SITE DEVELOPMENT PLANS FOR:
MONUMENT LDS CHURCH PARKING ADDITION
MONUMENT, COLORADO

LANDSCAPING PLAN
PROJECT NO. 21841-00CSCV
DRAWING NO.

LS01

EL PASO COUNTY PCD FILE NO: PPR-_____

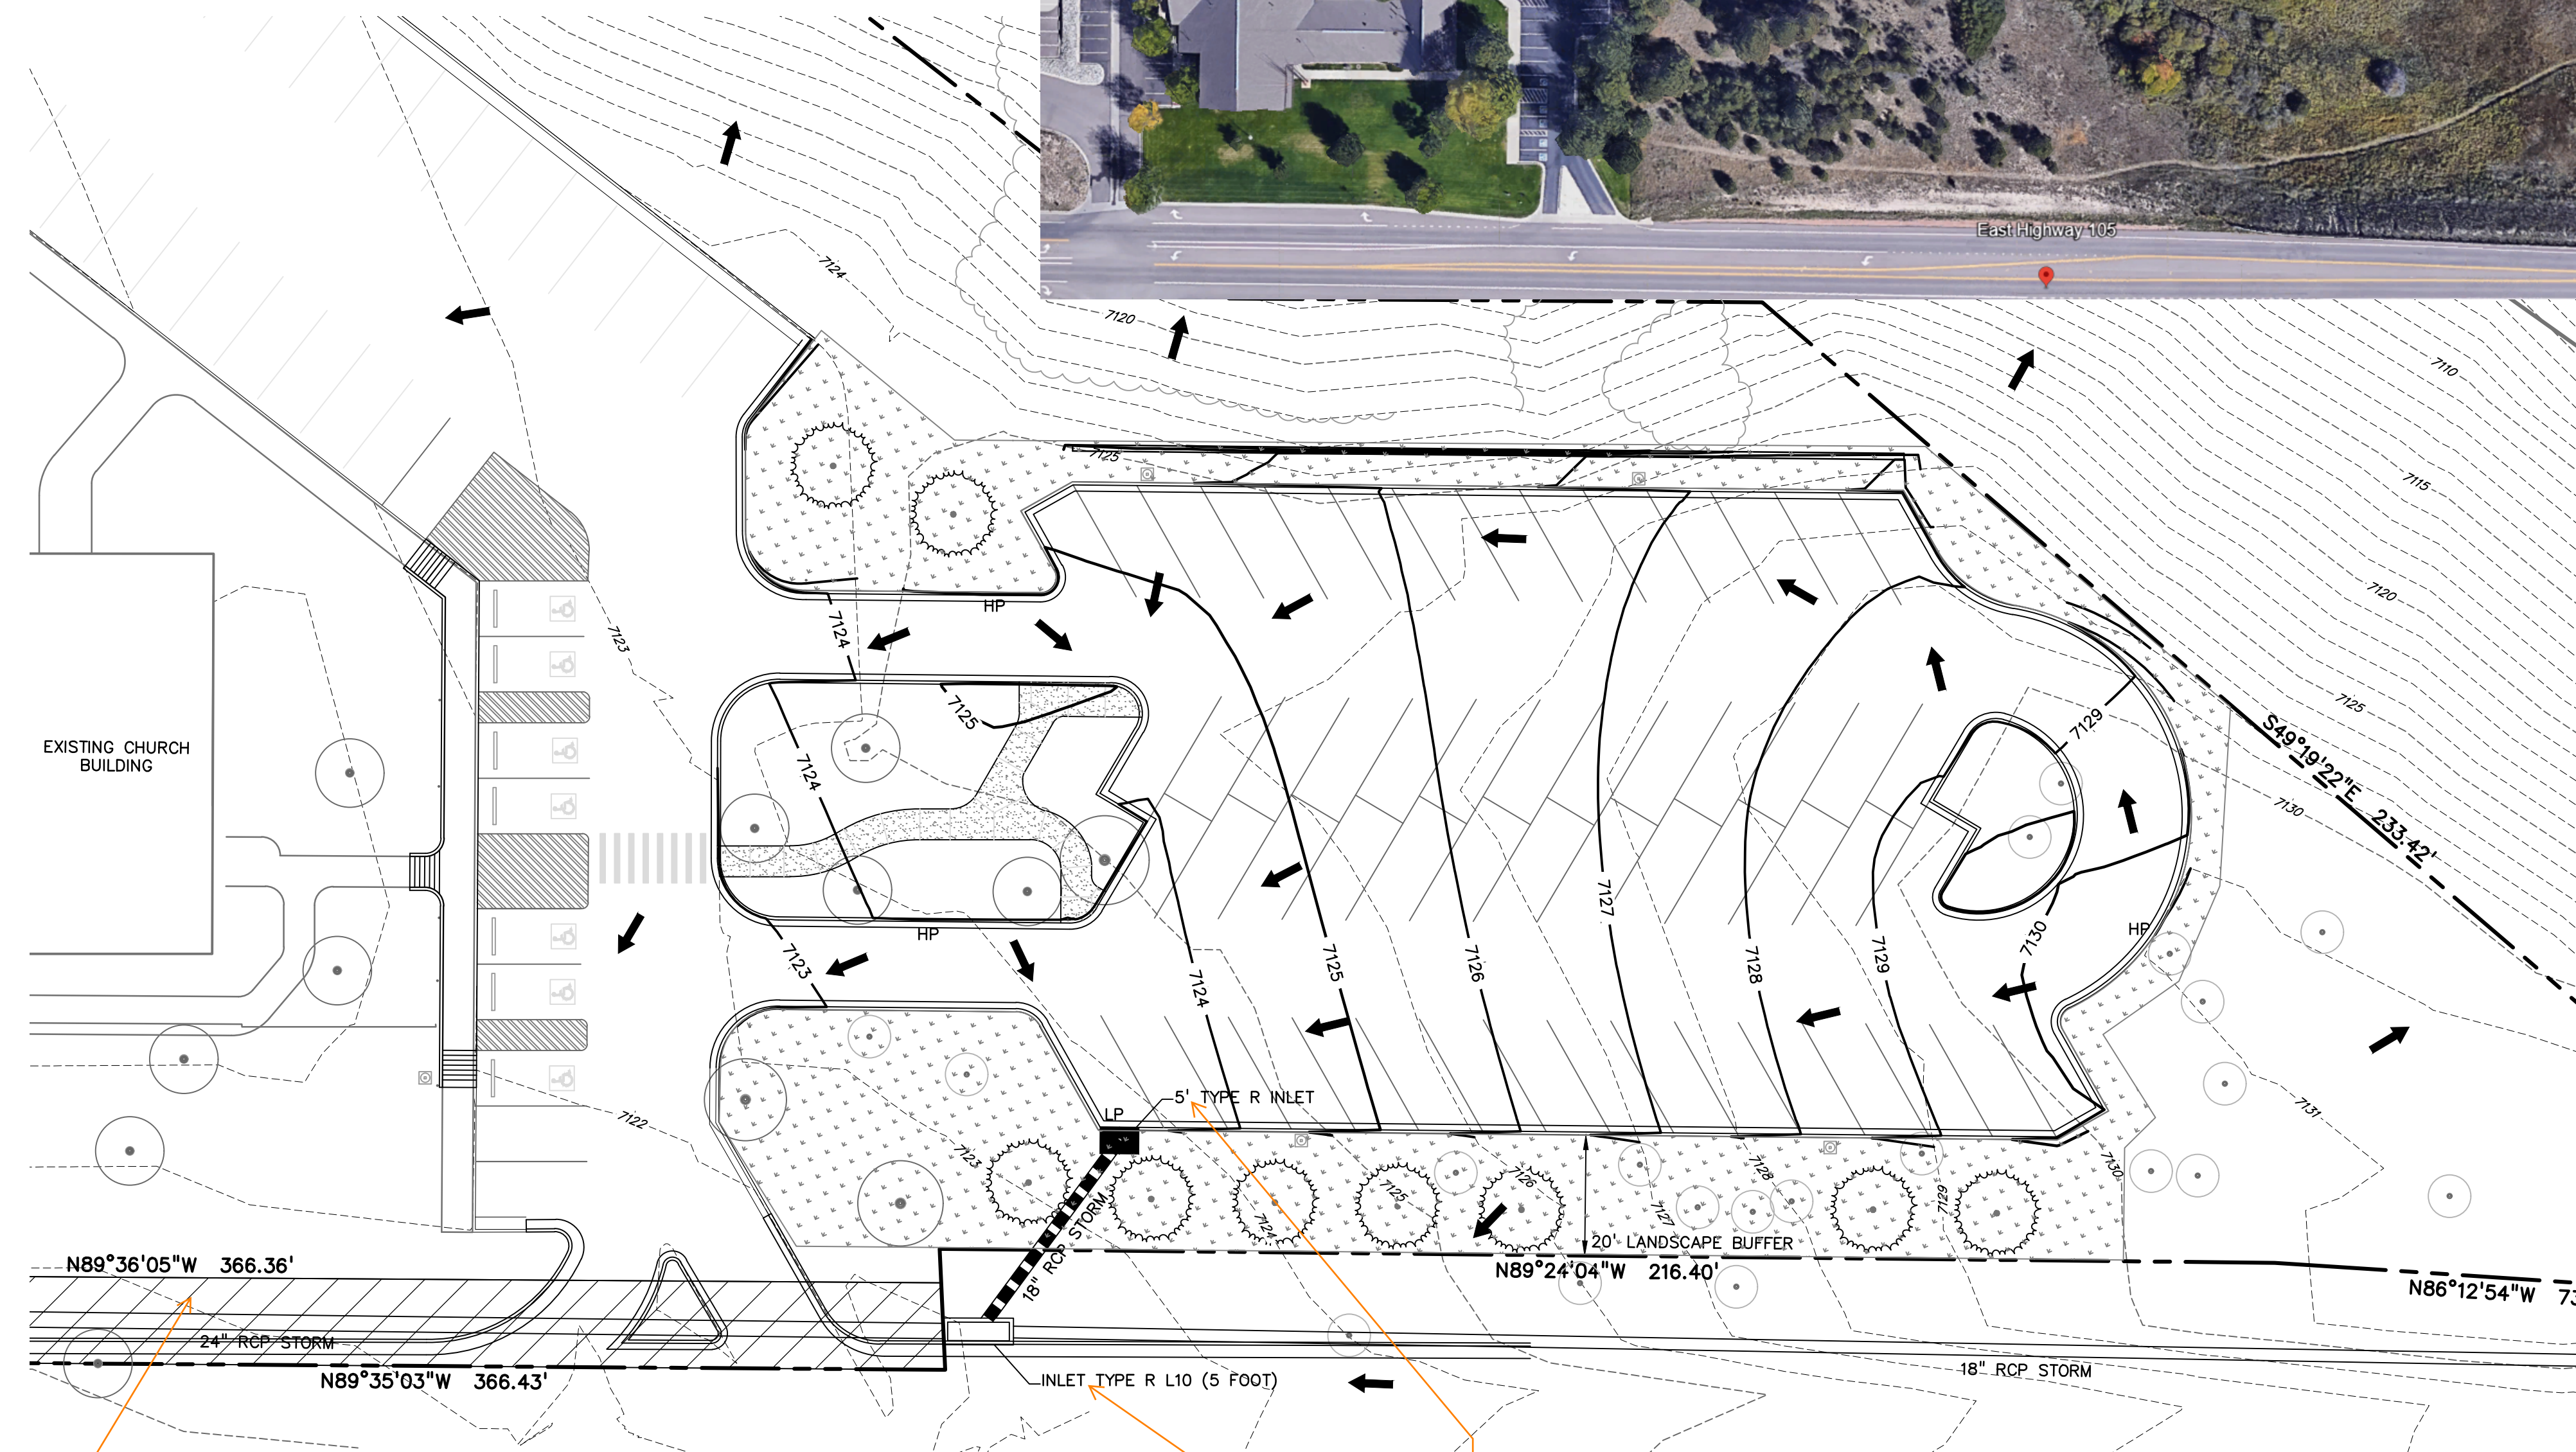
insert aerial to show vegetation existing so it counts...add a note existing vegetation to remain unless noted and counting towards parking lot landscape and roadway landscape. Show limit of disturbance on image and on drawing to show preservation of vegetation

What is this hatching for? It is not in the legend.

Clarify if the inlets are existing or proposed. One seems like it may be proposed and one seems existing but it needs to be clarified.
